Accessibility Survey

City of Downey Fontana Street - Brookshire Avenue to Downey Avenue

Date of Inspection
4/19/2017

Disability Access Consultants

Curb Ramp , Landings and Transitions : Top Landing Slope

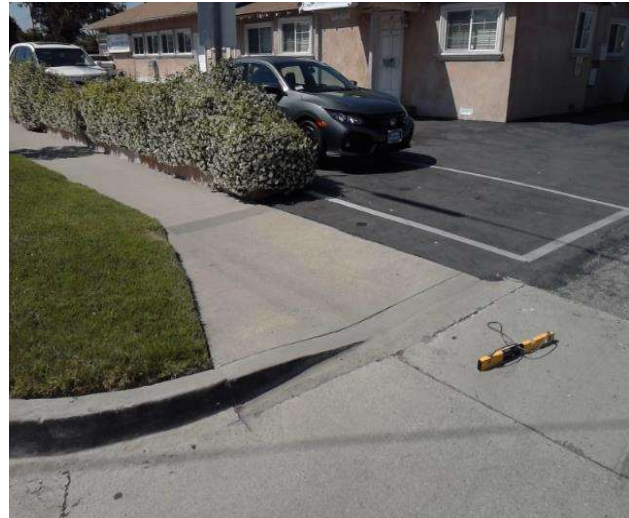
The slope at the top landing is greater than allowed.

On-Site Finding 2.90 percent

Provide a top landing surface that does not exceed the maximum slope and cross slope. Provide a sufficient maneuvering clearance that does not accumulate water.

Recommendation Up to 2.08 percent

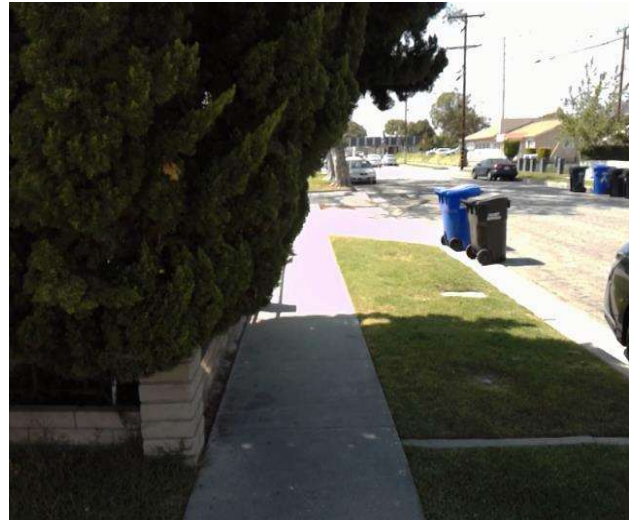
The leading edge of the protruding object is more than 4 inches from the edge of sidewalk.

On-Site Finding 38.00 inches

Install side extensions, modify, relocate, or lower the protruding object so that the leading edge protrudes less than 4 inches from the edge of sidewalk.

Sidewalks , Change in Level : Change in Level Non Beveled

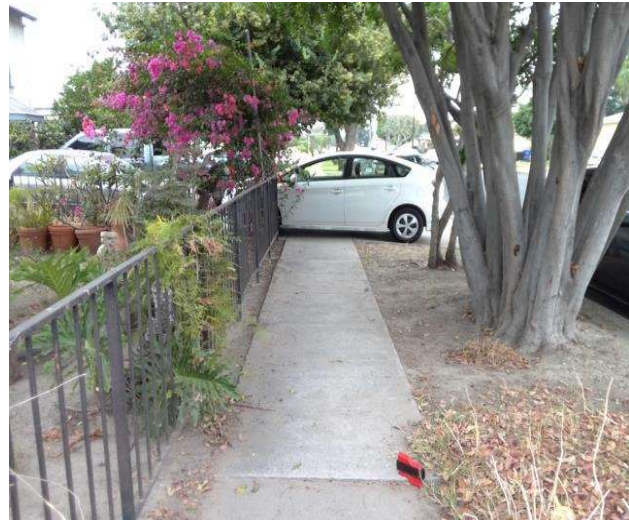
There is a change in elevation greater than recommended value.

On-Site Finding 1.00 inches

Ensure that the change in elevation is within the recommended value.

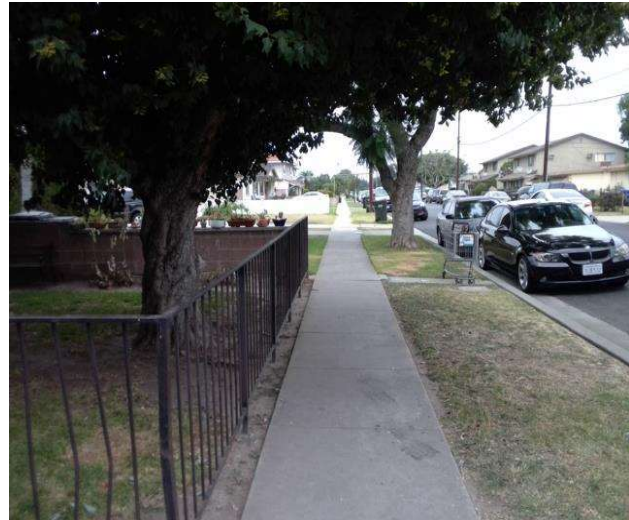
Sidewalk cross slope is not compliant.

On-Site Finding 3.30 percent for 24.00 feet

Repave the sidewalk surface with the recommended cross slope.

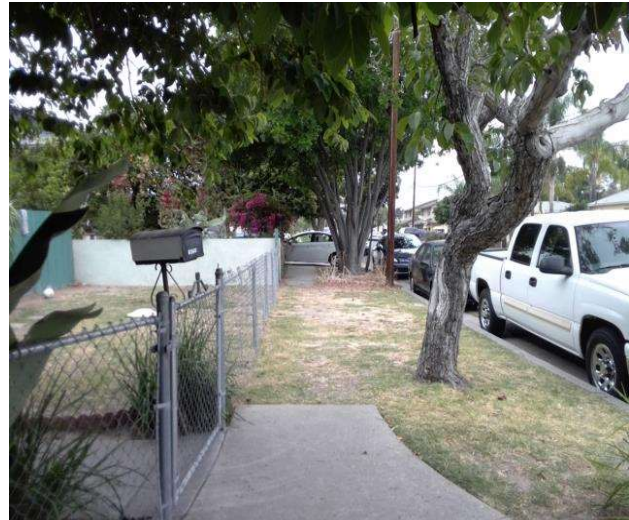
There is no 60X60 turn area at every 200 feet.

On-Site Finding Not Found

Provide a 60X60 turn every 200 feet on the sidewalk.
